UNITED STATES PATENT AND TRADEMARK OFFICE

APPLICATION NO.	FILING DATE	FIRST NAMED INVENTOR	ATTORNEY DOCKET NO.	CONFIRMATION NO.
10/690,828	10/23/2003	Ewen James Crawford Kellar	553-81	5416
23117	7590	10/05/2005	EXAMINER	
NIXON & VANDERHYE, PC 901 NORTH GLEBE ROAD, 11TH FLOOR ARLINGTON, VA 22203			IMAM, ALI M	
			ART UNIT	PAPER NUMBER
			3737

Office Action Summary	Application No.		Applicant(s)	
	10/690,828		CRAWFORD KELLAR ET AL.	
	Examiner		Art Unit	
	Ali Imam		3737

DETAILED ACTION

Fig. 2

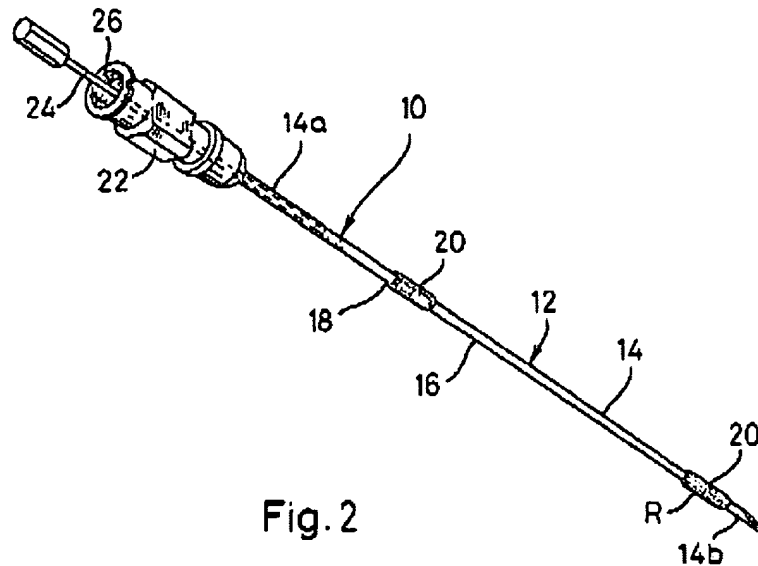
23. Claims 1, 3-7, 9-10, 17-22, 24, 26-29, 31-32, and 38-43 are rejected under 35 U.S.C. 103(a) as being unpatentable over Joseph (WO 98/18387 of record) in view of Violante et al. (US 6,106,473). Joseph discloses in page 9, line lines 1-28 and shows in Fig. 2 (reproduced below), an instrument (10) insertable into a medium and being capable of detection by sonic imaging equipment comprising an elongate member (14) for insertion into the medium and

having a region the position of which it is desirable to monitor, bubble generating means (effervescent material 32 of Fig. 3) for generating a plurality of discrete mobile gas bubbles at the region, whereby the bubbles are detectable by sonic imaging equipment wherein the bubble generating means comprises two elements, sodium hydrogen carbonate and citric powder, (col. 4, line7) which, upon contact with each other in the presence of fluid react with each other to produce the gas bubbles within a fluid (col. 3, lines 1-5). Joseph further teaches in Fig. 3 (reproduced below) a fluid permeable carrier material (30). Joseph teaches a single radially displaced layer (coating 20) containing both elements of the bubble generating means.

Fig. 3

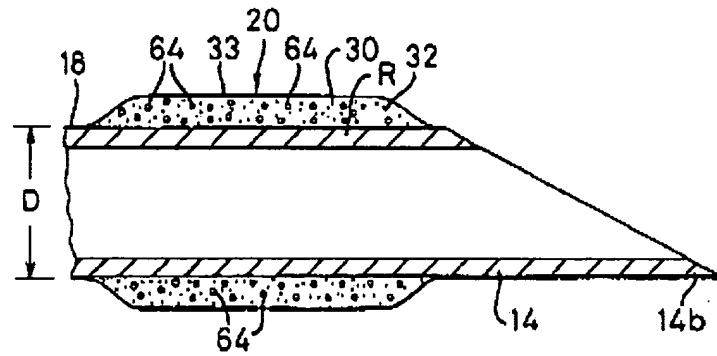
Joseph differs from the claimed invention because it does not explicitly disclose that the two elements of the bubble generating means comprise first and second radially displaced layers of the elements within the carrier material.

FIG. 1

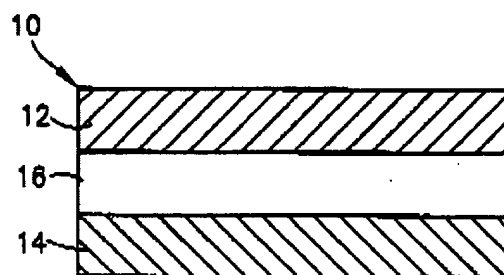
Carlin et al. (hereinafter "Carlin") teaches in Fig. 1 (reproduced below), an effervescent system containing three layers wherein the first, outer, layer (12) contains either the acidic element (e.g., the citric acid) or the basic element (e.g., the sodium hydrogen carbonate), the second, inner, layer (14) contains the other element that is not selected for the first layer (12), and the third, intermediate, layer (16) that is not chemically involved with the acidic or the basic

element (col. 3, lines 50-54). Carlin further discloses that the intermediate layer is used for separating the first and second layers containing the two elements for improving the handling of

the two elements (col. 3, line 6) and thereby minimizing reaction between layers prior to immersion in a liquid (col. 4, lines 30-32). The applicant may argue that the effervescent system of Carlin is from a different field of endeavor (dental cleanser). However, both Joseph's effervescent materials and Carlin's effervescent materials perform the same function that is to produce gas bubbles. Violante teaches in col. 8, lines 51-57, that gas bubbles are acoustically reflective in ultrasound applications and increases the visibility of a structure containing a coating that is capable of releasing the gas bubbles in a medium.
